# PEUGEOT/CITROËN THERMOSTAT REDESIGN TO OVERCOME OVERHEATING ISSUES

Issue Date: 23/09/19 Issue Number: COTB0025F

**APPLICATION :** Citroën Berlingo, C3, C4, DS3, Peugeot 207, 308, 3008, 5008, Partner

**APPLICABLE REFERENCES :** FTK102 / FTK481

OLD DESIGN	NEW DESIGN
 <p>FTK102</p>	 <p>FTK481</p>

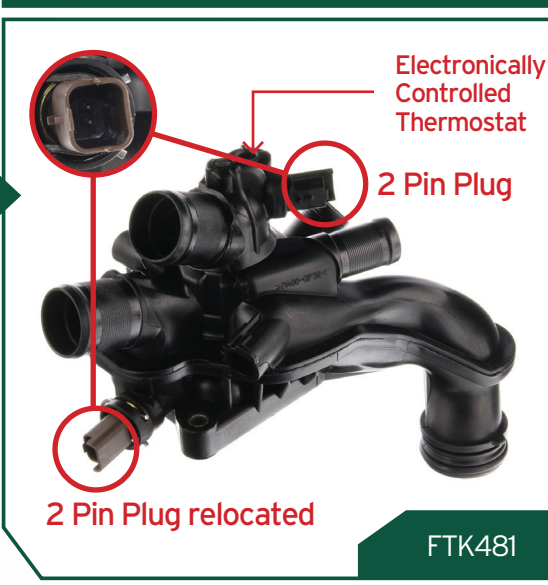
Due to an increase in overheating issues & symptoms such as an erratic temperature gauge, erratic running, radiator fan run-on, or poor heater function in the above vehicles, the O.E.M. have modified the design of the Thermostat housing. Following the O.E. specification, we have replaced the old design FTK102 with the new latest design FTK481. The latest design benefits from an electronically controlled thermostat, a reinforced structure, and a new configuration of sensors.

We have highlighted the key differences below so that you are clear that the latest part, although visually different to what may be on the vehicle, is in fact the correct product.

**PLEASE NOTE:**  
The modified version has had the lower 2 Pin connector relocated, therefore, a new cable may also be required to carry out the modification.  
New Cable: FTS3091 - Thermostat Wiring Harness

If your vehicle has the FTK102 or equivalent, then it is recommended that this is replaced with the updated version FTK481. It is advised that following replacement of these components, the software is checked and re-programmed / flashed to ensure that it is operating with the latest version.
